Groundwater Application Review Summary Form

Application # G- 18852

GW Reviewer Michael Thoma Date Review Completed: 06/16/2020

PUBLIC INTEREST REVIEW FOR GROUNDWATER APPLICATIONS

Stream-Depletion Model Results

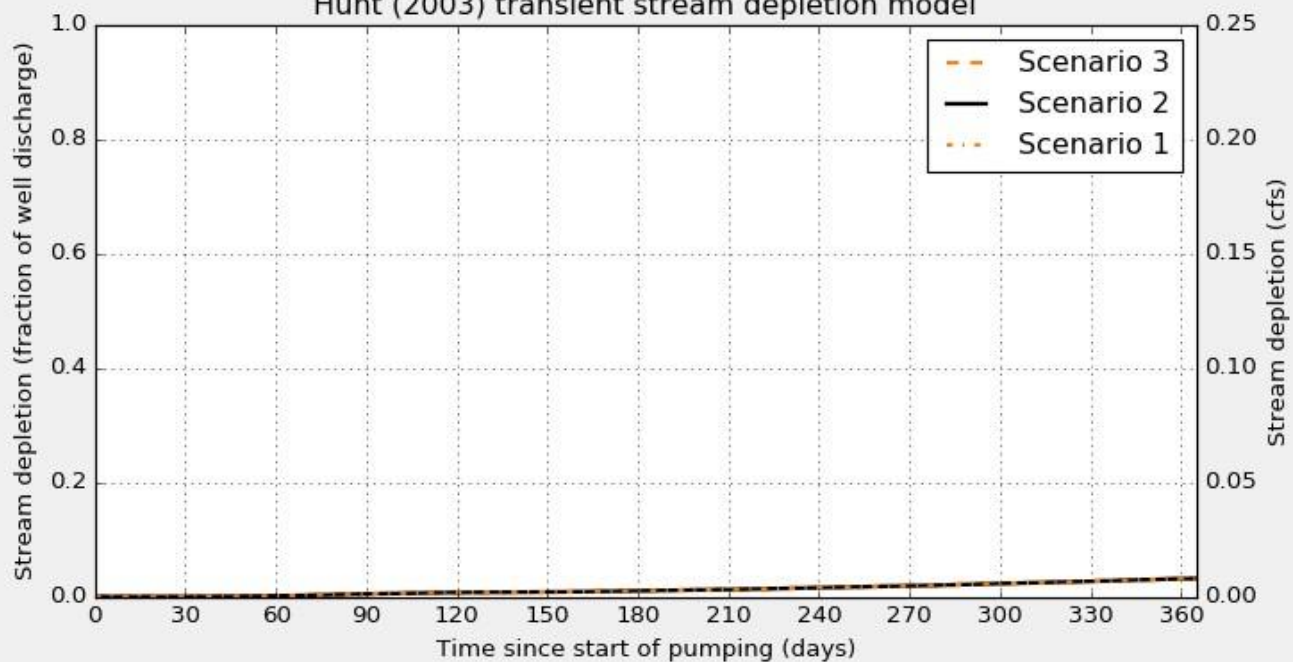
Basis for impact evaluation: Stream-depletion was estimated to Snake Creek using the Hunt (2003) stream-depletion model with parameter values informed by Gannett et al. (2012) and using methods previously used by the Department for estimating stream-depletion in the Klamath Basin. The main control on stream-depletion for this application is the distance to the nearest, hydraulically-connected stream reach, which is based on assumed static water levels and on proposed construction. Stream-depletion estimates are assumed to be different if the well is not constructed as proposed.

C6. **SW / GW Remarks and Conditions:** The applicant's proposed POAs would be producing from an aquifer that has been found to be hydraulically connected to surface water – specifically Snake Creek and the Sprague River – at distances of just over 3 miles. Stream-depletion was estimated using standard practices of the Department and the proposed rate and level of impact does not reach the level where PSI is assumed.
